COMMONWEALTH OF PENNSYLVANIA
PENNSYLVANIA GAME COMMISSION

ADDENDUM NO. 1

SOLICITATION NO. 6100057419
PROJECT: PGC-HQ-22-01
Property Line Fencing Contract
OPENING DATE/TIME: December 22, 2022 2:00 PM

TECHNICAL SPECIFICATION NO. 1 - CHAIN LINK FENCE

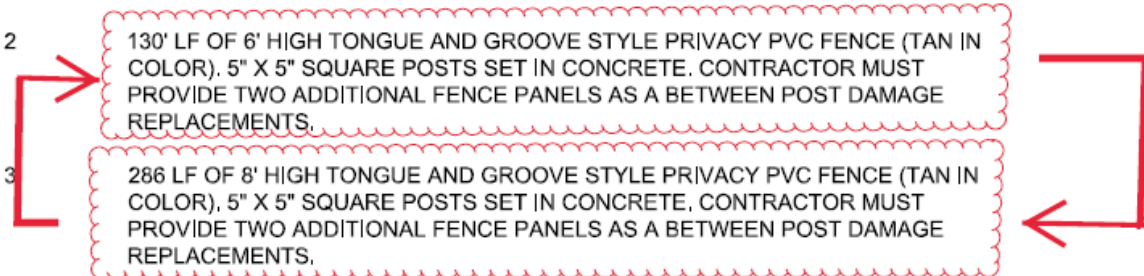
The following specification section of "1.4 Procedure" is to be revised and read interpreted as below:

1.4 - PROCEDURE

A – Placing Fence – Identify post locations. Auger footing holes (9-inch-diameter for line posts and terminal posts). The depth of holes for line posts is 24-inches. The depth of holes for terminal posts is 36-inches. Set posts, centered and plumb, on the bottom of the holes. Place and tamp backfill. Use 50% earth backfill and 50% concrete backfill for line posts and full depth concrete backfill for terminal posts. Crown the finished surface to shed water.
